### RETROFIT RIGID TROUGH SHAFT FOR REPLACING THE INTER-AXLE DIFFERENTIAL IN FRMP-13/16-S AXLES

The inter-axle differential can be converted to a rigid trough shaft construction in such applications where the conventional inter-axle differentials are subject to excessive stress.

Picture 1. Items to be removed

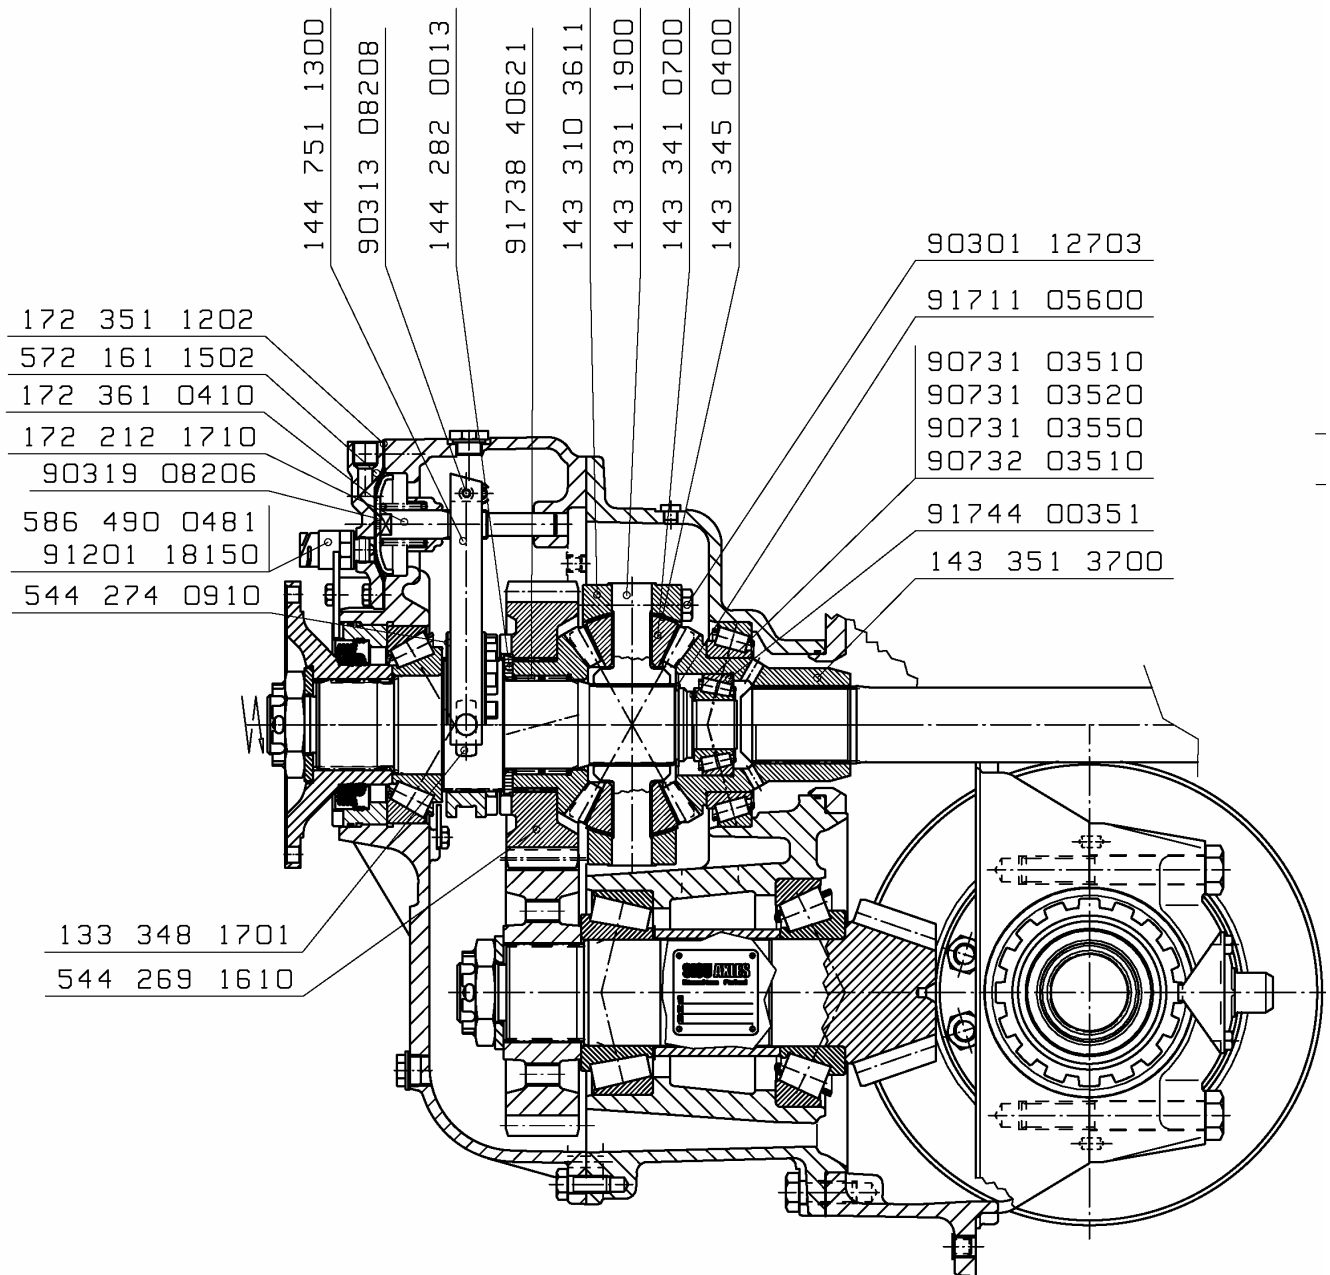
When converting the inter-axle to a through shaft construction the items mentioned in Picture No. 1. have to be removed. In Picture No. 2. there are the new items to be installed.

Picture 2. Items to be installed

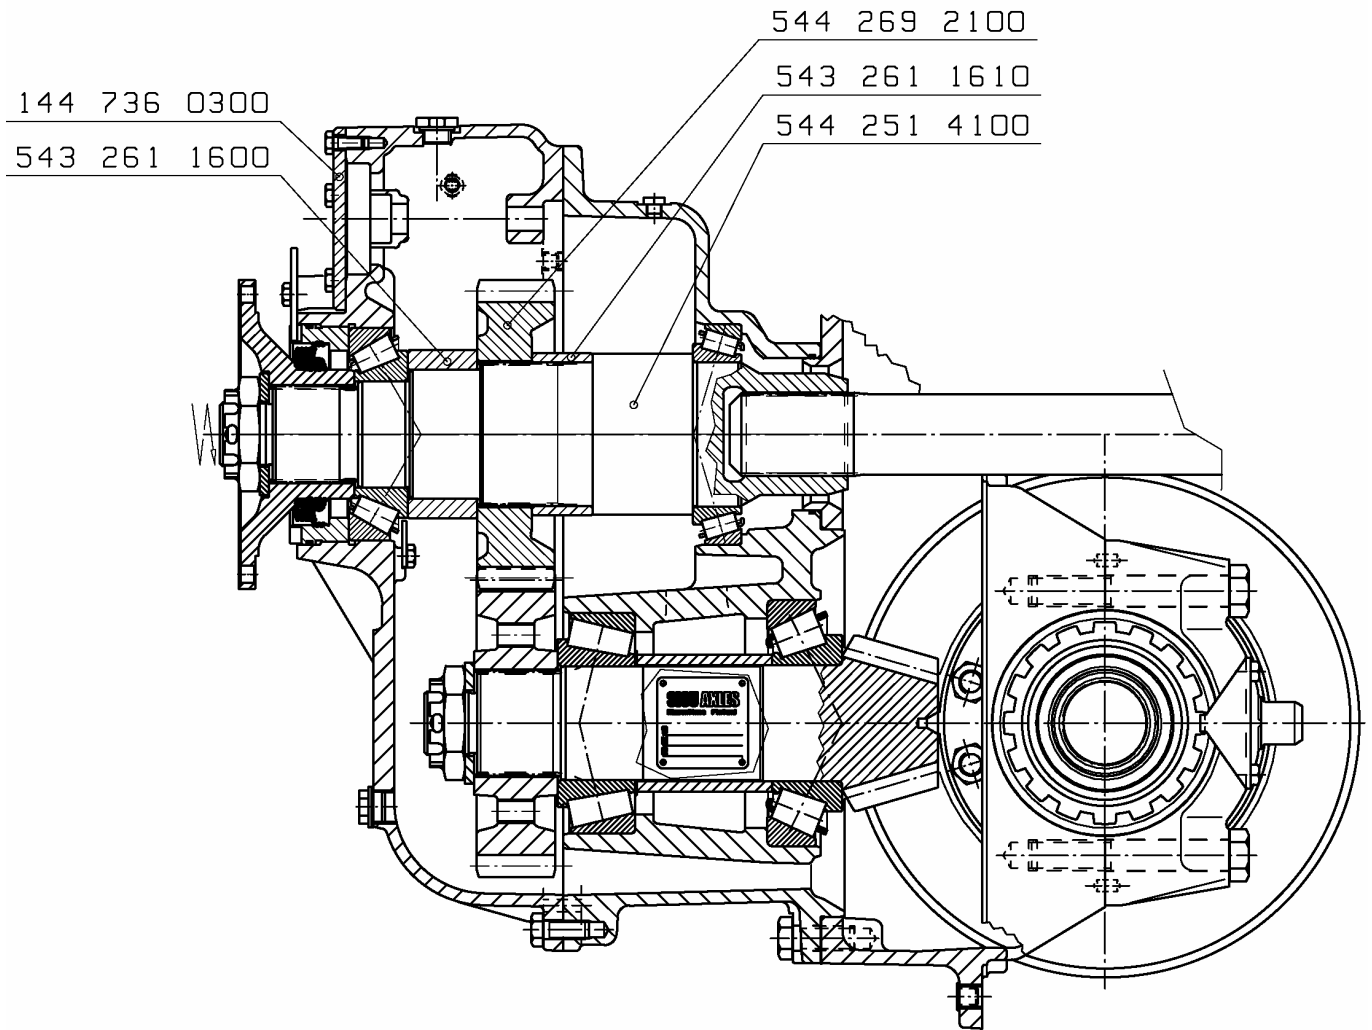
Note! This conversion can only be made to axles with final ratios 4.92:1 or higher.
